Technical Tip

Model: DTR-4.6/5.6/6.6/7.6

Subject: Remote and Wired remote does not respond well to input commands

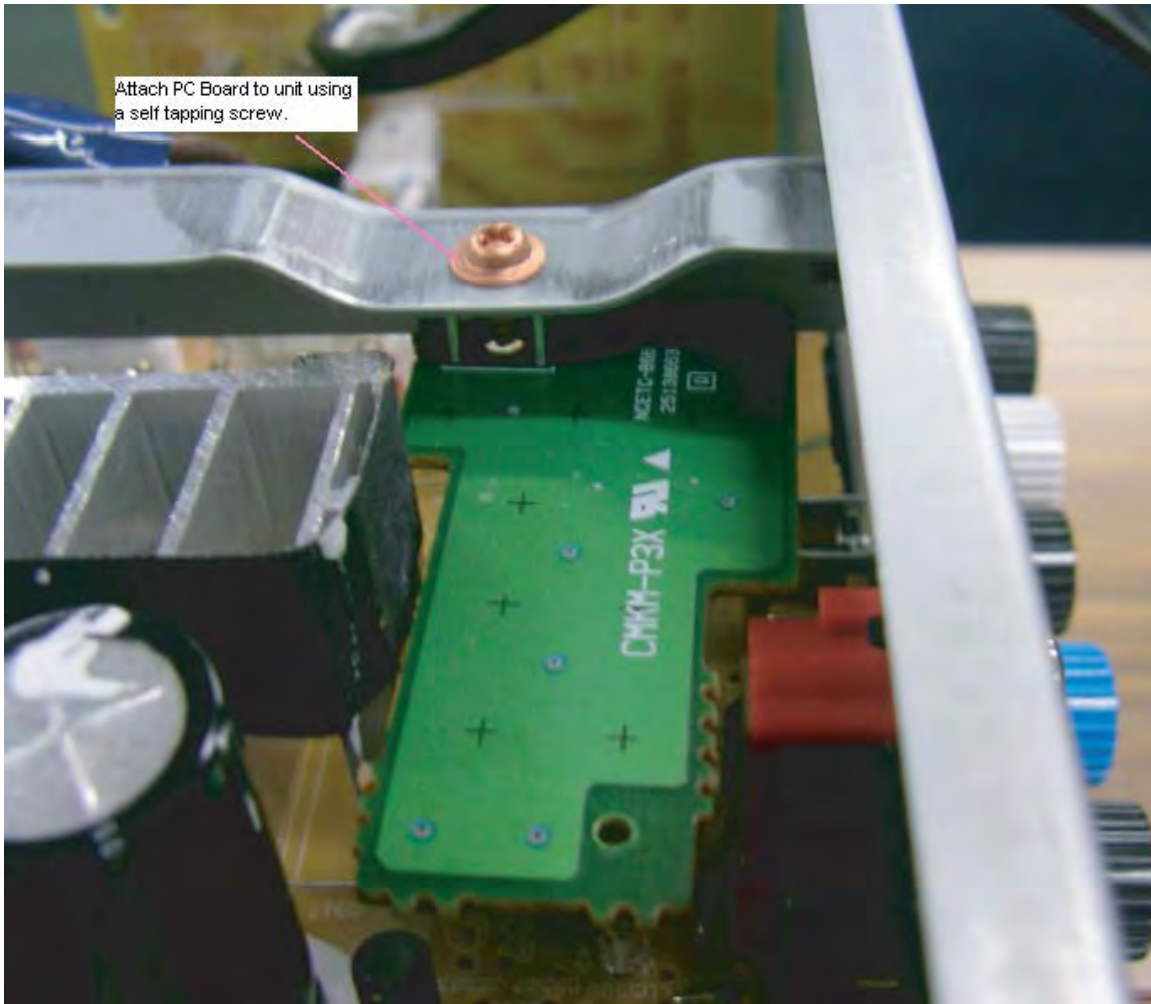
Symptom: When using remote or an external IR controller connected to the rear panel IR input the set may not respond properly to IR commands.

Solution: Install the IR Shield PC Board as described. Cover the IR Remote Sensor.

- 1.) Solder the Terminal Connector to the PC board.
- 2.) Attach the PCB you assembled to the set using a self tapping screw.

Attach PC Board to unit using a self tapping screw.
